**Assessment of Sixteen (16) Protected-Size Trees
at and adjacent to
62 Ellenwood Avenue
Los Gatos, California**

Prepared for:
Sean Mullin, Associate Planner
Town of Los Gatos Community Development Department
110 E. Main Street
Los Gatos, CA 95030

Report by CTA
6/3/2020

Walter Levison, Contract Town Arborist 6/3/2020
Markup of Sheet L0.0 Dated 4/23/2020 Showing
Sixteen (16) Protected-Status Trees
(Both on and Adjacent to the 62 Ellenwood Property)

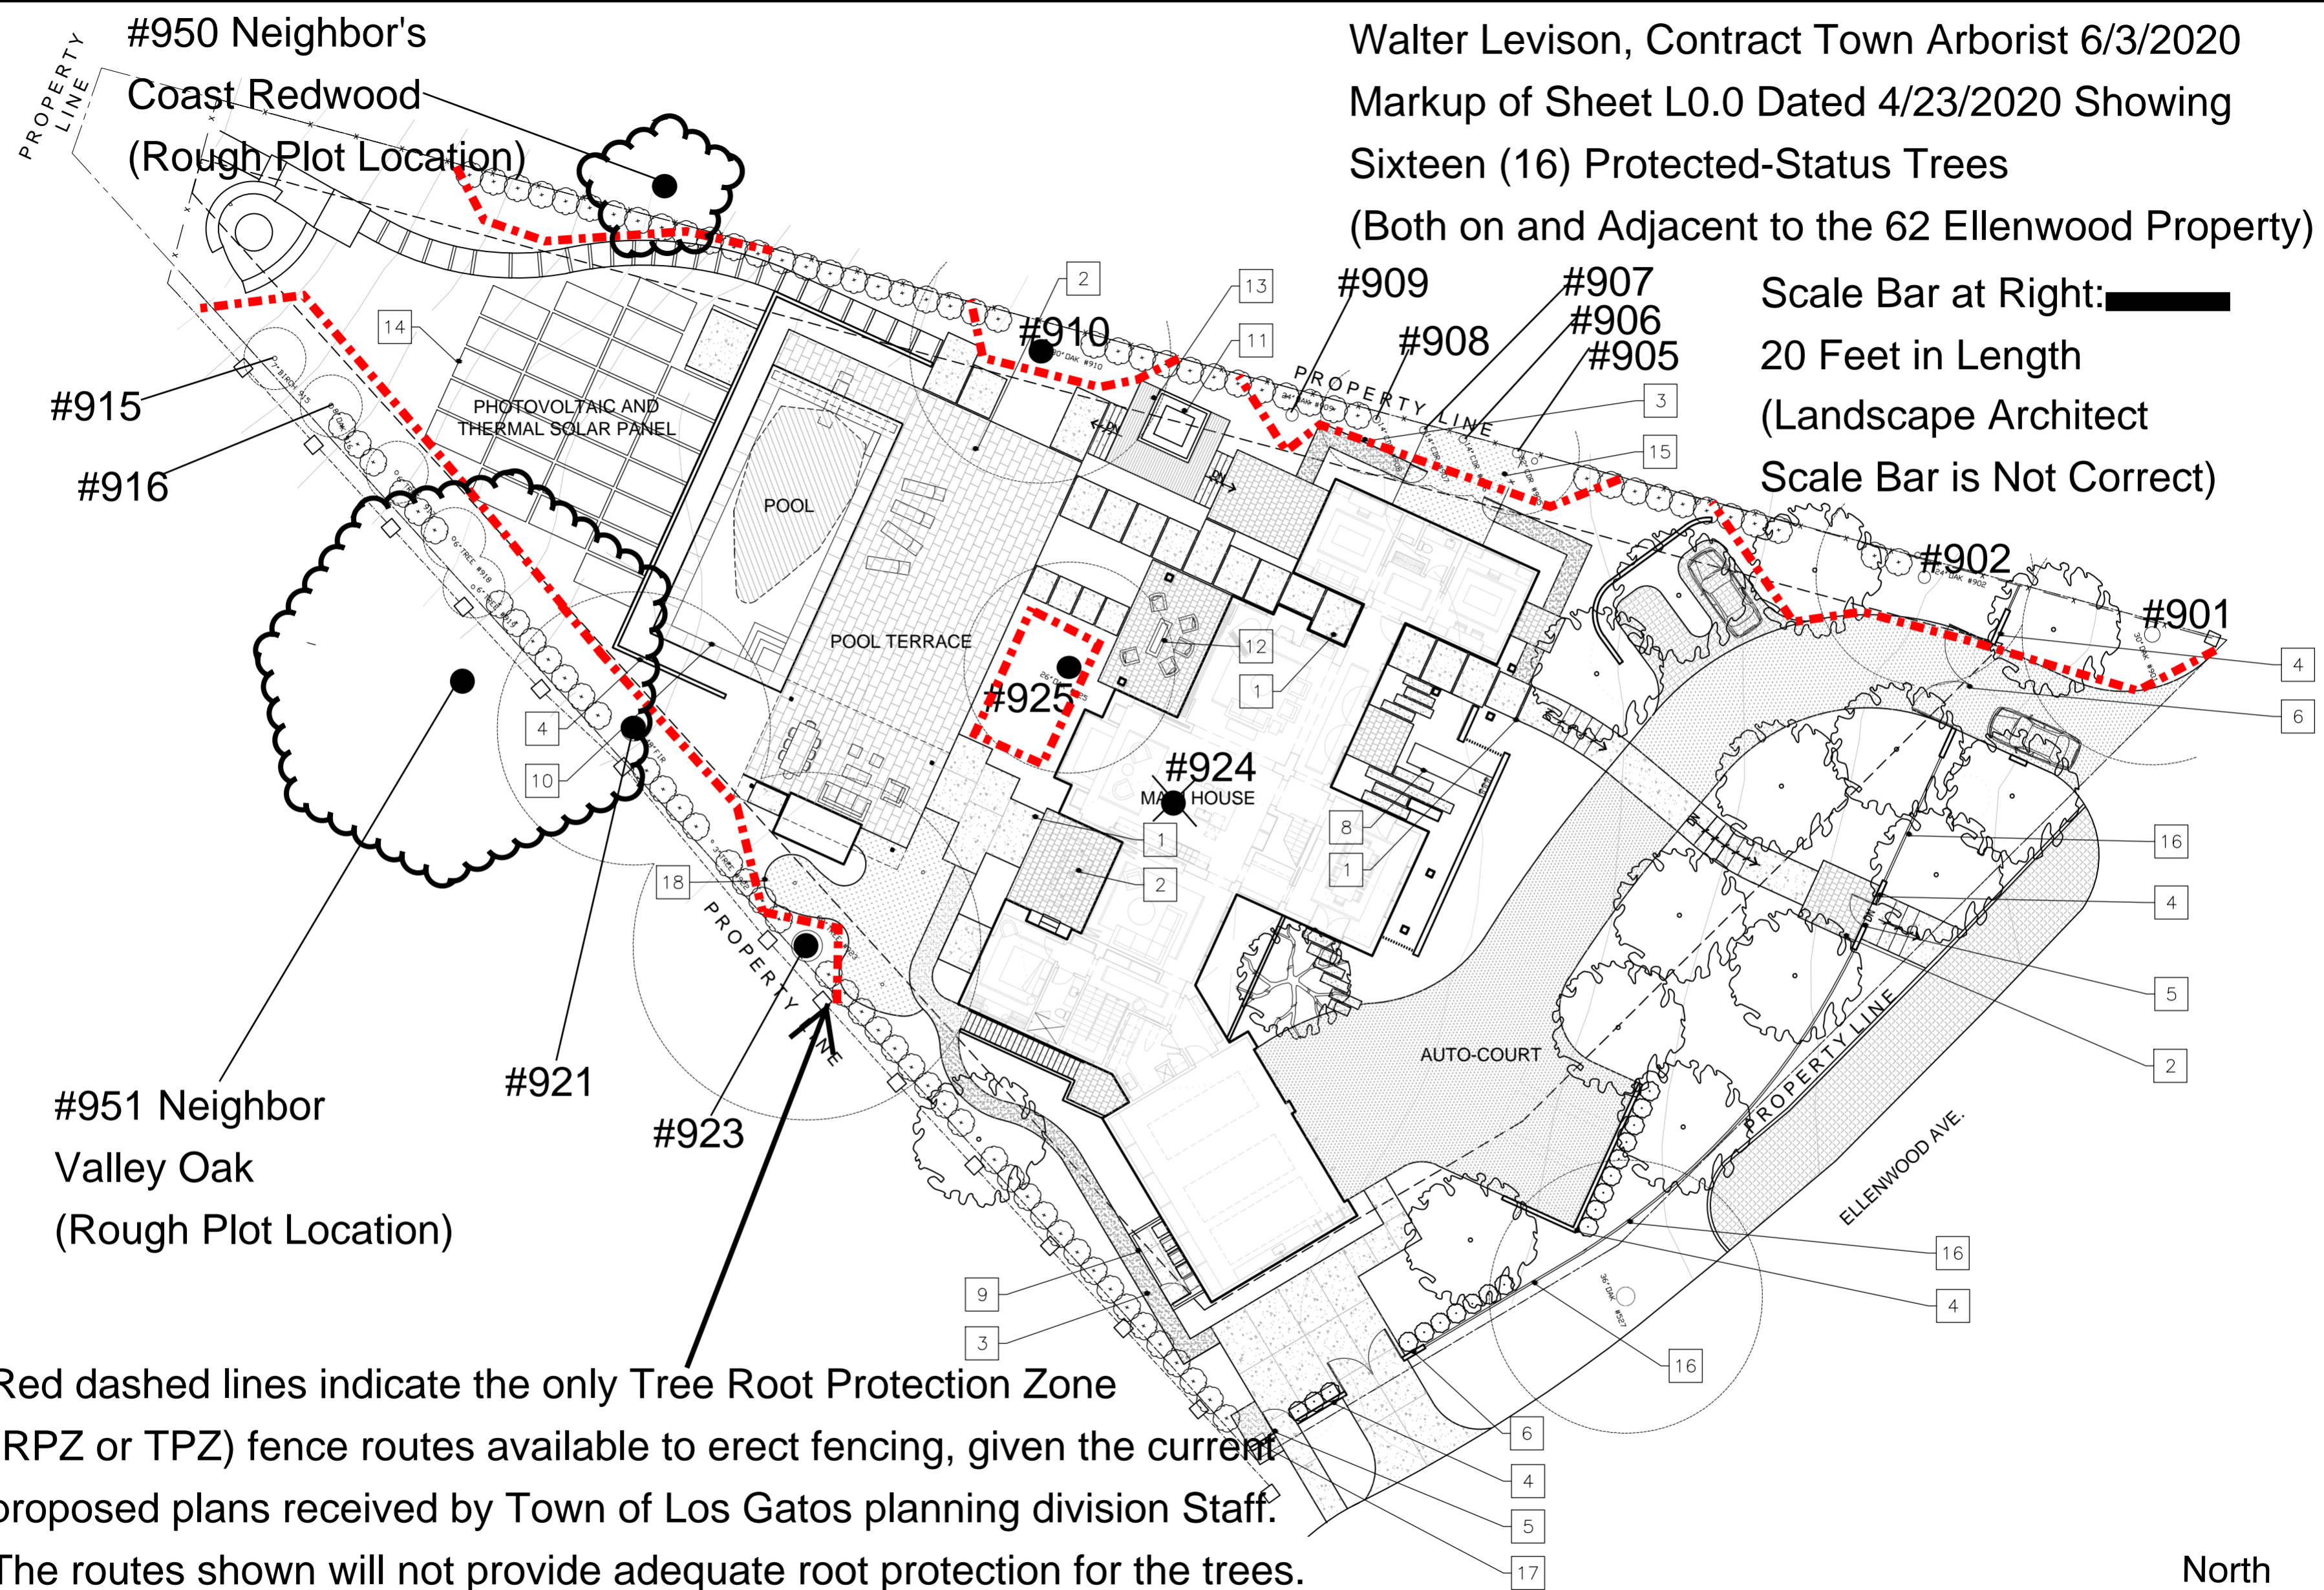
Scale Bar at Right: 
20 Feet in Length
(Landscape Architect
Scale Bar is Not Correct)

Red dashed lines indicate the only Tree Root Protection Zone (RPZ or TPZ) fence routes available to erect fencing, given the current proposed plans received by Town of Los Gatos planning division Staff. The routes shown will not provide adequate root protection for the trees. See the arborist report for analysis of construction-related impacts to trees expected to occur as a result of applicant-proposed site work.

See the CTA's red dashed lines indicating chain link fence routing, on the attached tree map markup.
